RHODE ISLAND DEPARTMENT OF TRANSPORTATION

**Bridge Group 53 - Union Village RR**

NOTICE TO PROSPECTIVE BIDDERS

ADDENDUM NO. 3 Prospective bidders and all concerned are hereby notified of the following changes in the Plans, Specifications, Proposal and Distribution of Quantities for this contract. These changes shall be incorporated in the Plans, Specifications, Proposal and Distribution of Quantities, and shall become an integral part of the Contract Documents.

**STANDARD PLAN SYMBOLS & STANDARD LEGEND**

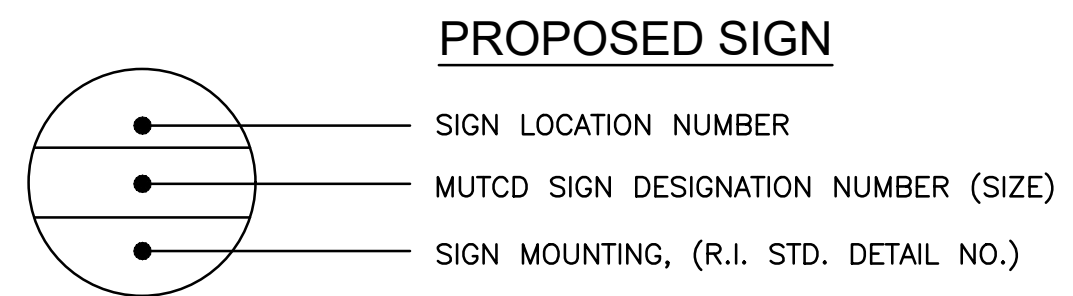
1. VOLUME 1 SHEET 2 - STANDARD PLAN SYMBOLS & STANDARD LEGEND  
Remove and replace Sheet 2 in its entirety with revised Sheet 2 (R-1) attached to this Addendum No. 3. The following line types have been updated to display correctly: GUARDRAIL, RETAINING WALL, FIELD STONE WALL, FENCE, CUT AND MATCH, BALED HAY RI STD 9.1.0, BALED HAY & SILT FENCE RI STD 9.3.0. These line types have been updated to display correctly as indicated on subsequent sheets attached to this Addendum No. 3.

**DRAINAGE & UTILITY PLAN  
NO. 1**

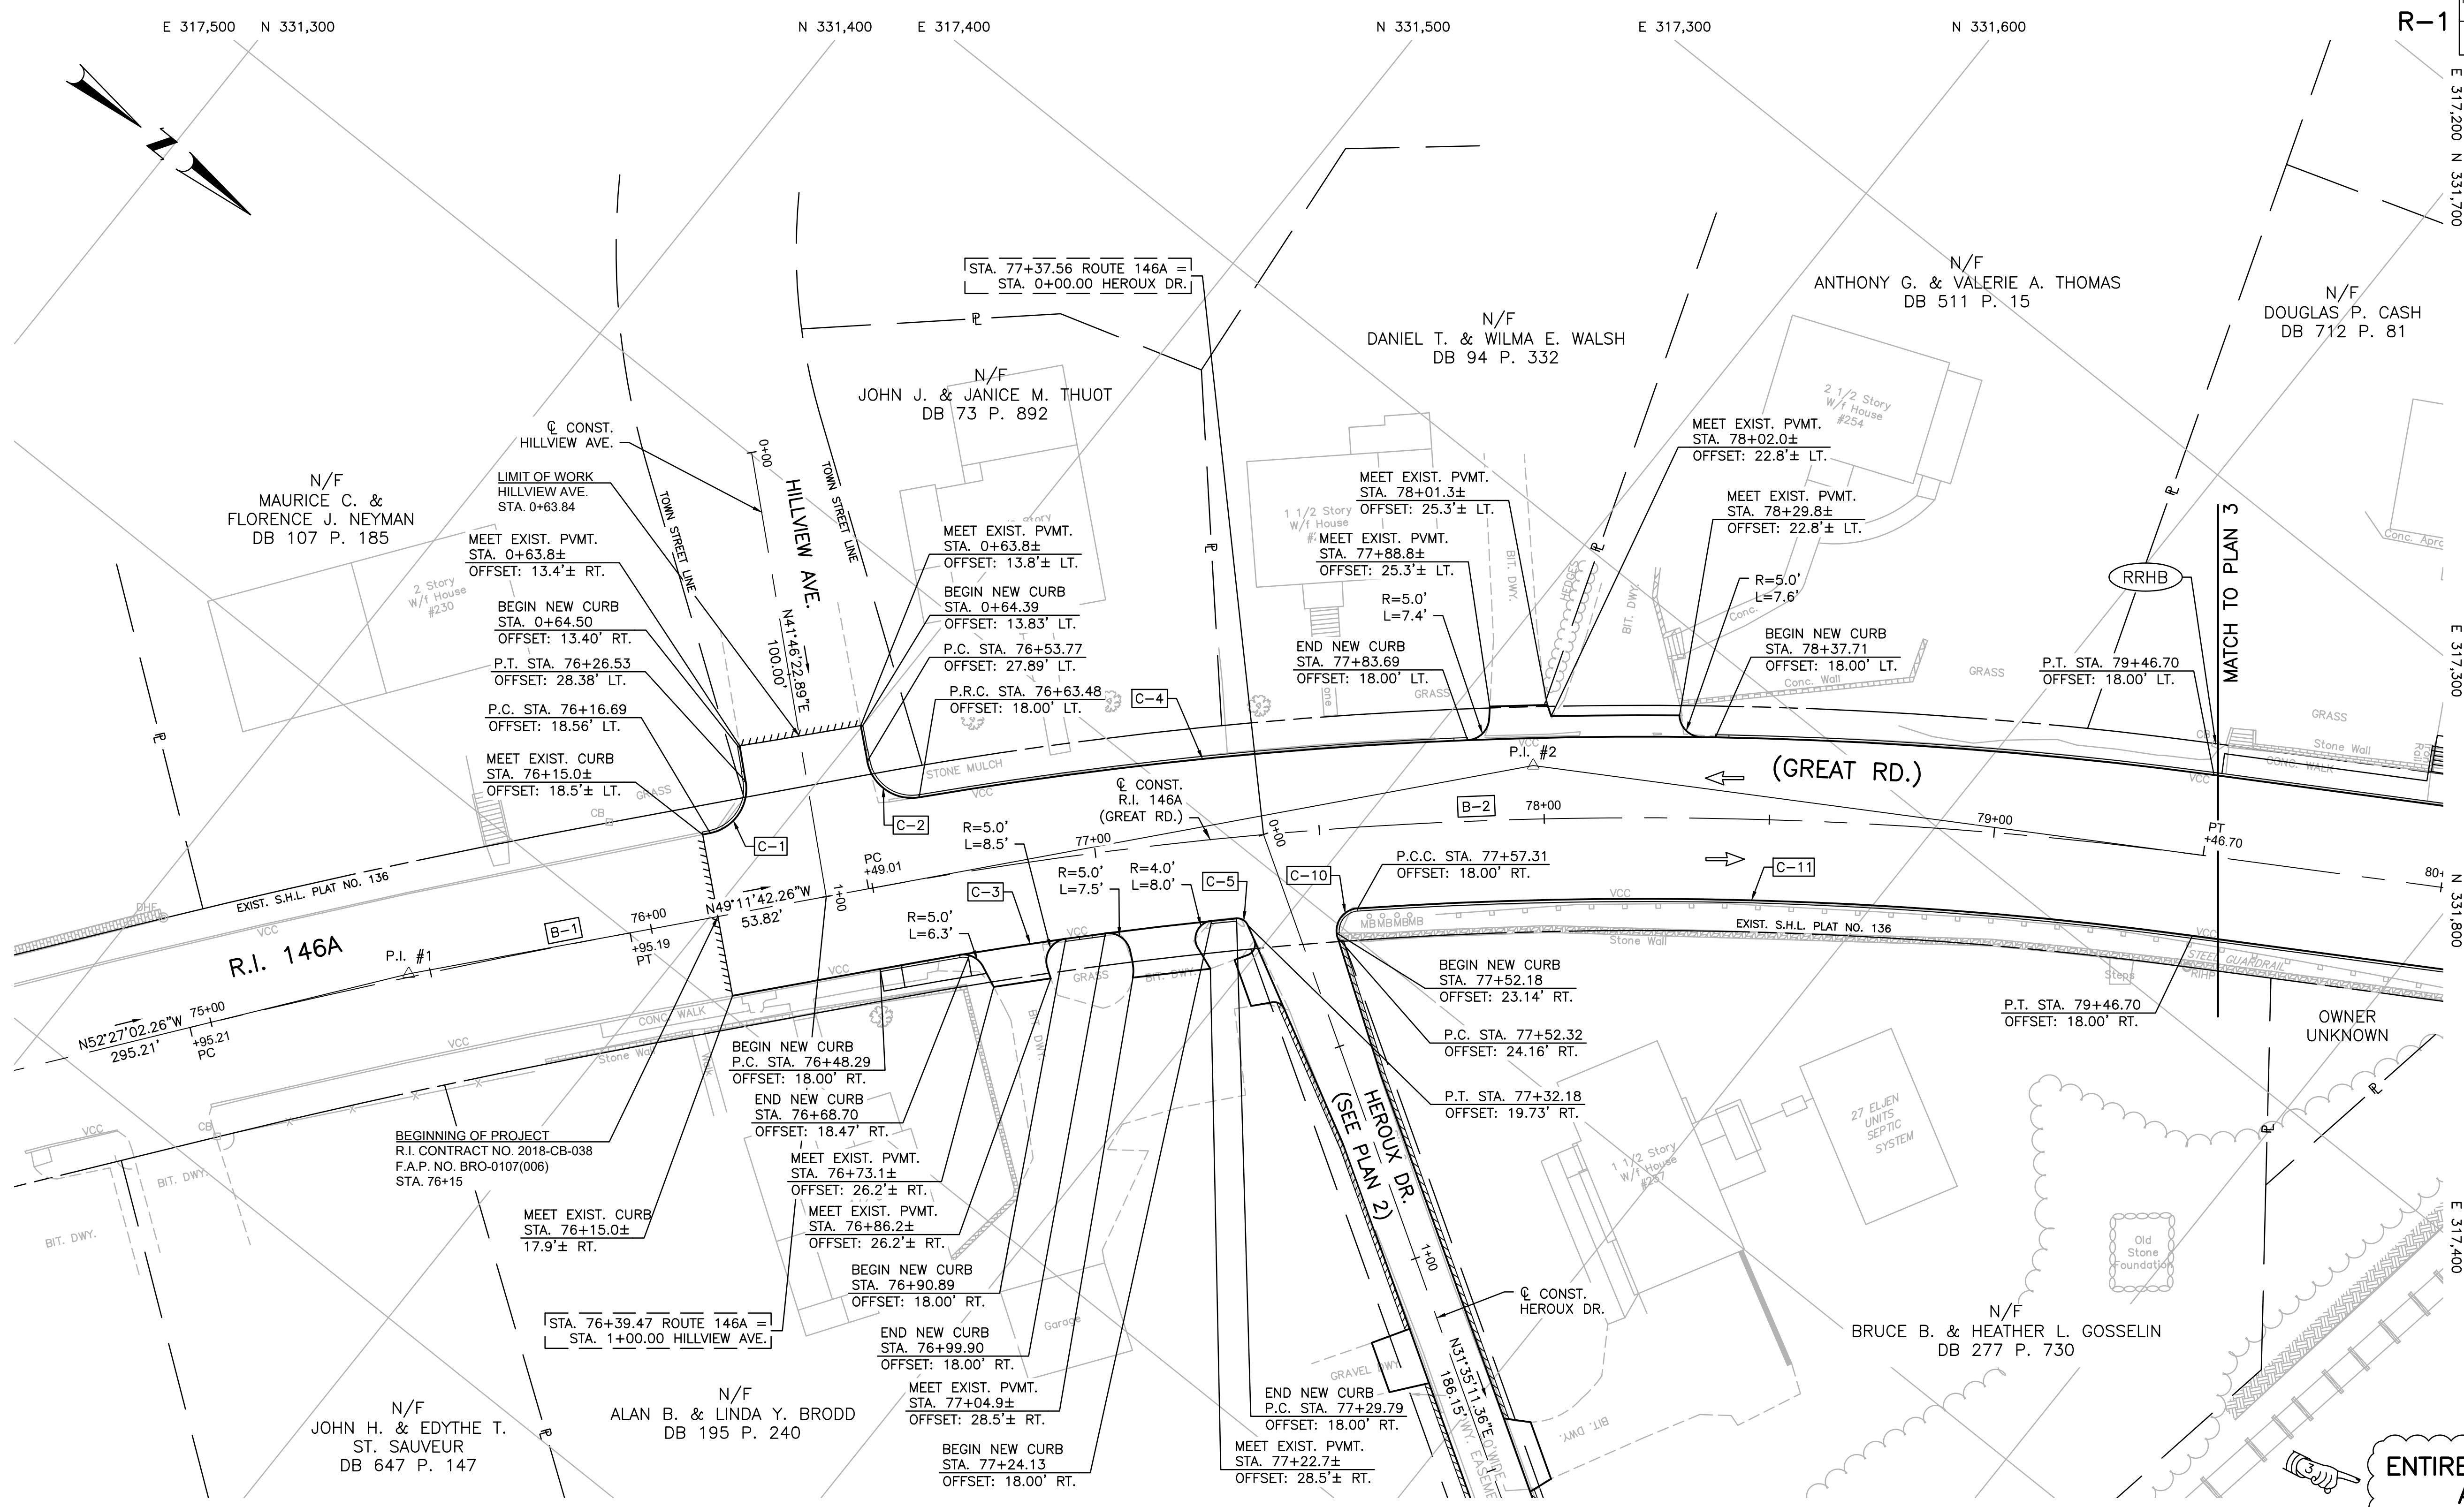
6. VOLUME 1 SHEET 14 - DRAINAGE & UTILITY PLAN NO. 1  
Remove and replace Sheet 14 in its entirety with revised Sheet 14 (R-1) attached to this Addendum No. 3. Line types have been updated to display correctly based on Sheet 2 revisions.

**LOCATION PLAN NO. 1**

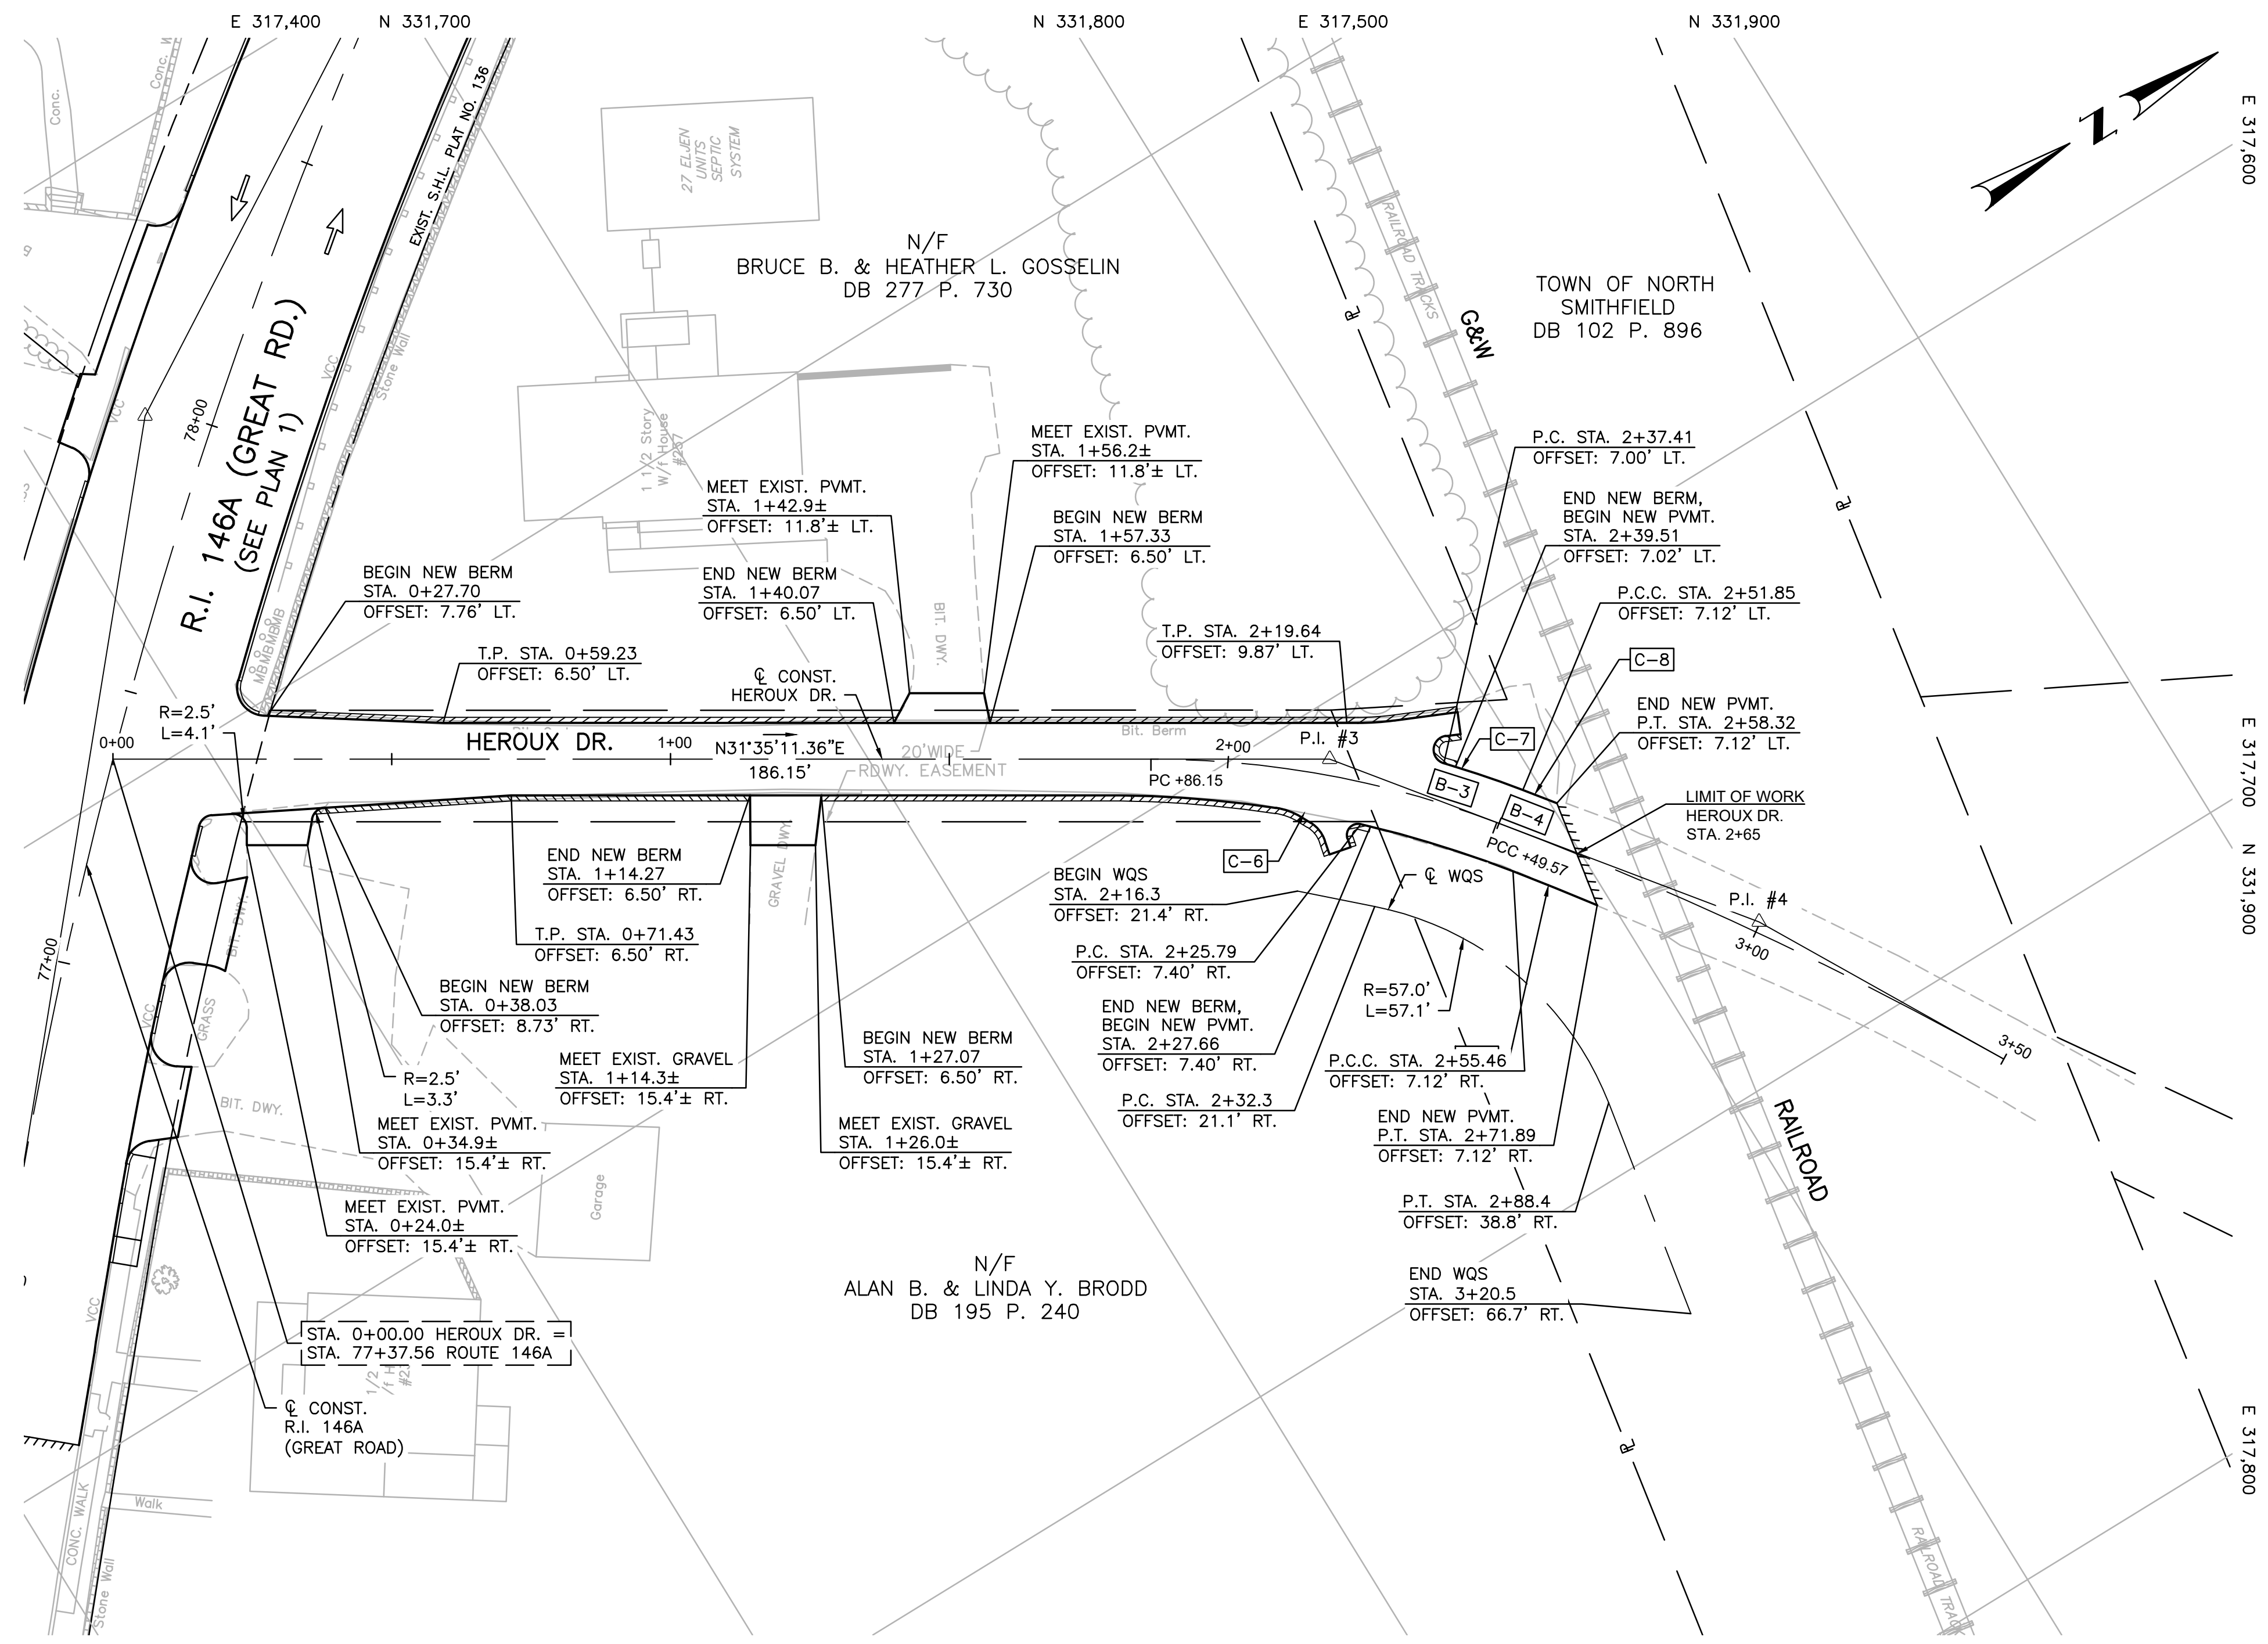
8. VOLUME 1 SHEET 17 - LOCATION PLAN NO. 1  
Remove and replace Sheet 17 in its entirety with revised Sheet 17 (R-1) attached to this Addendum No. 3. Line types have been updated to display correctly based on Sheet 2 revisions.
